SOLICITATION AMENDMENT
MODIFICATION DE L'INVITATION

Title - Sujet Expansion parking at La Macaza	
Solicitation No. - N° de l'invitation 21301-188288/A	Amendment No. - N° modif. 010
Client Reference No. - N° de référence du client 21301-18-8288	Date 2018-02-15
GETS Reference No. - N° de référence de SEAG PW-\$MTC-410-14537	
File No. - N° de dossier MTC-7-40063 (410)	CCC No./N° CCC - FMS No./N° VME
Solicitation Closes - L'invitation prend fin at - à 02:00 PM on - le 2018-03-15	
F.O.B. - F.A.B. Plant-Usine: <input type="checkbox"/> Destination: <input checked="" type="checkbox"/> Other-Autre: <input type="checkbox"/>	
Address Enquiries to: - Adresser toutes questions à: Spina, Angelina	Buyer Id - Id de l'acheteur mtc410
Telephone No. - N° de téléphone (514) 496-3785 ()	FAX No. - N° de FAX (514) 496-3822
Destination - of Goods, Services, and Construction: Destination - des biens, services et construction:

AGRANDISSEMENT DU STA TONNEMENT EXPANSION OF EXISTING PARKING FACILITIES

CLARIFICATION NO. 2

GENIE ELECTRIQUE ELECTRICAL ENGINEERING
 CONSTRUCTION - RÉSEAU PRISES POUR VEHICLES
 CONSTRUCTION - ELECTRICAL VEHICLES OUTLETS
 L.-J. FORBES, INC.

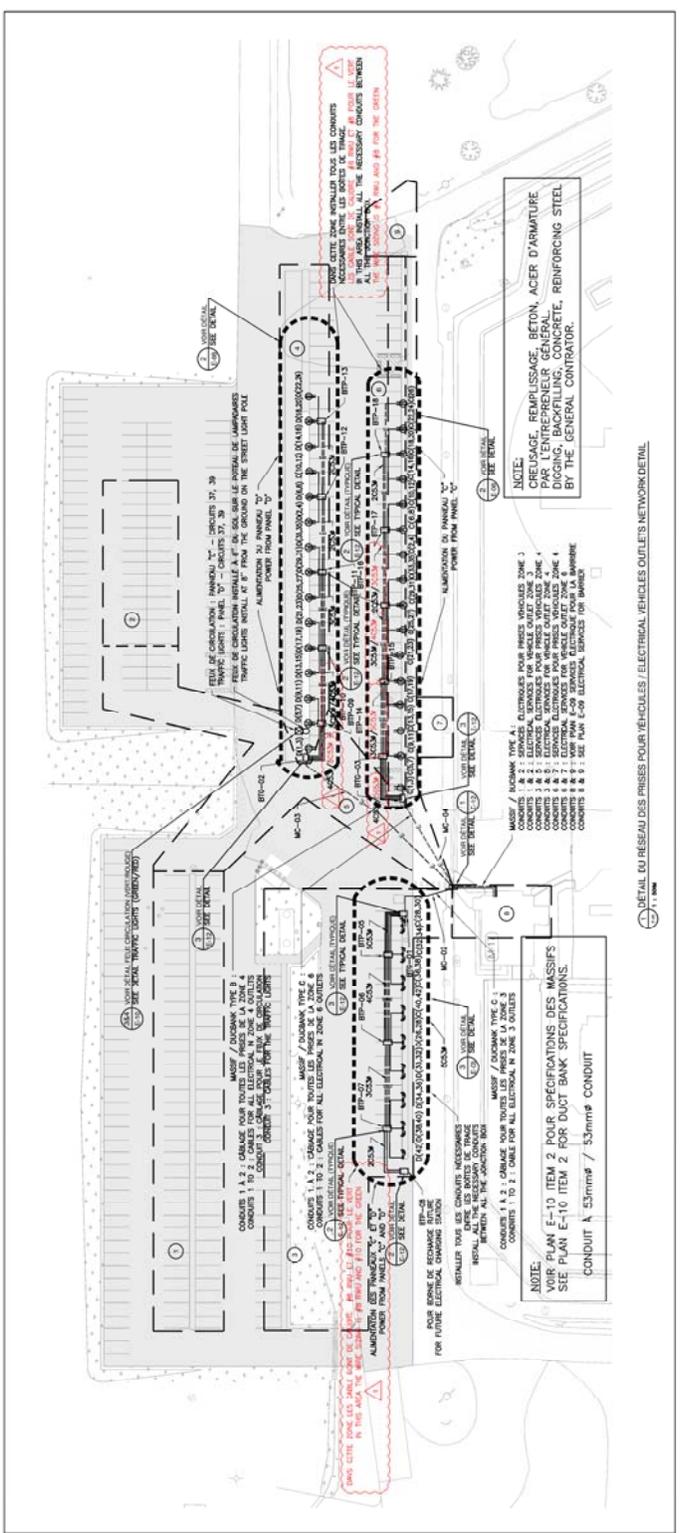
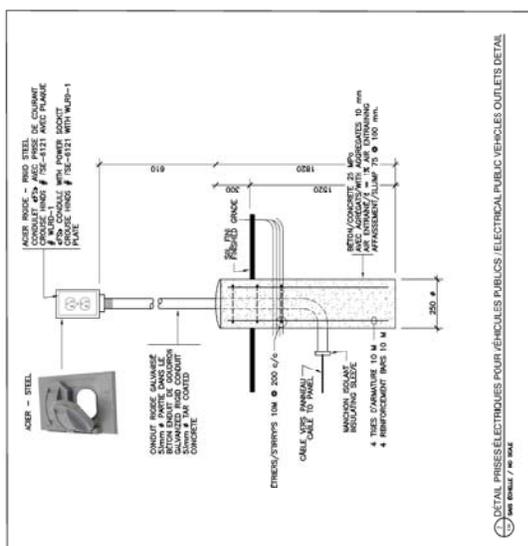
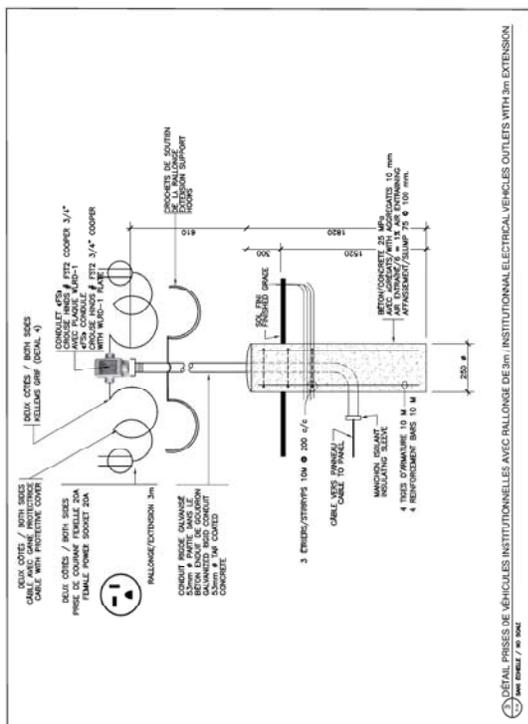
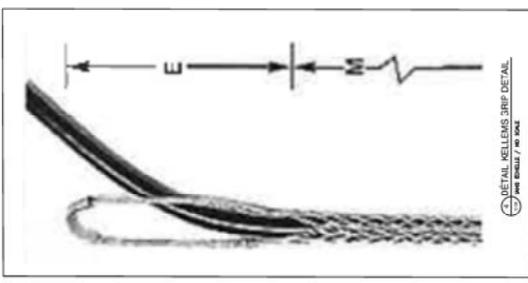
2. You must delete in its totality the **BID AND ACCEPTANCE FORM (BA)** and replace it by the adjoining document.
3. Please find enclosed herewith the addition of a plan.
4. Please cancels and replaces completely 01 00 50 with the adjoining document.
5. Please find enclosed herewith questions and answers (CLARIFICATION NO. 2).
